**Mountain Valley Pipeline, LLC
Mountain Valley Pipeline Project
Docket No. CP16-10-000**

**Response to Post-Draft Environmental Impact Statement
Environmental Information Request #2 Issued March 20, 2017**

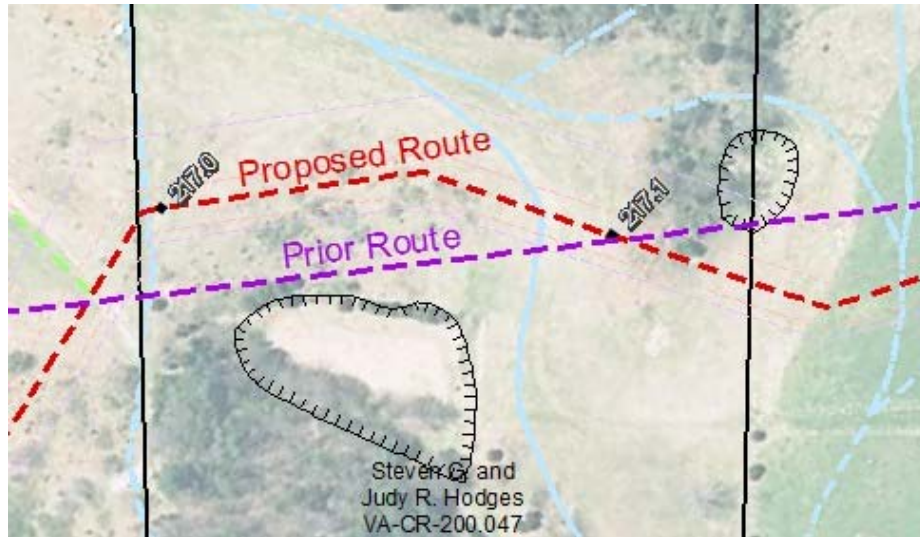
- c. Mountain Valley expects to submit a response by April 7, 2017.
- d. Mountain Valley expects to submit a response by April 7, 2017.
- e. Mountain Valley previously responded to a data request from the Commission with respect to a November 2015 submission by Mr. Hodges. See the response to Resource Report 6, Question 4, submitted April 21, 2016. Mr. Hodges’s submittal on December 22, 2016 is largely identical to his November 2015 submittal. Mountain Valley supplements its prior response to Mr. Hodges with the following information.

Based on field visit observations by the Mountain Valley Karst Specialist Team, the Project alignment was adjusted on the Hodges property in

October 2016 to increase the distance between the alignment and the two sinkholes Mr. Hodges identified in his December 2016 letter. This is demonstrated in the snippet below from the relevant alignment sheet. This alignment adjustment provides additional separation buffer from the sinkholes.
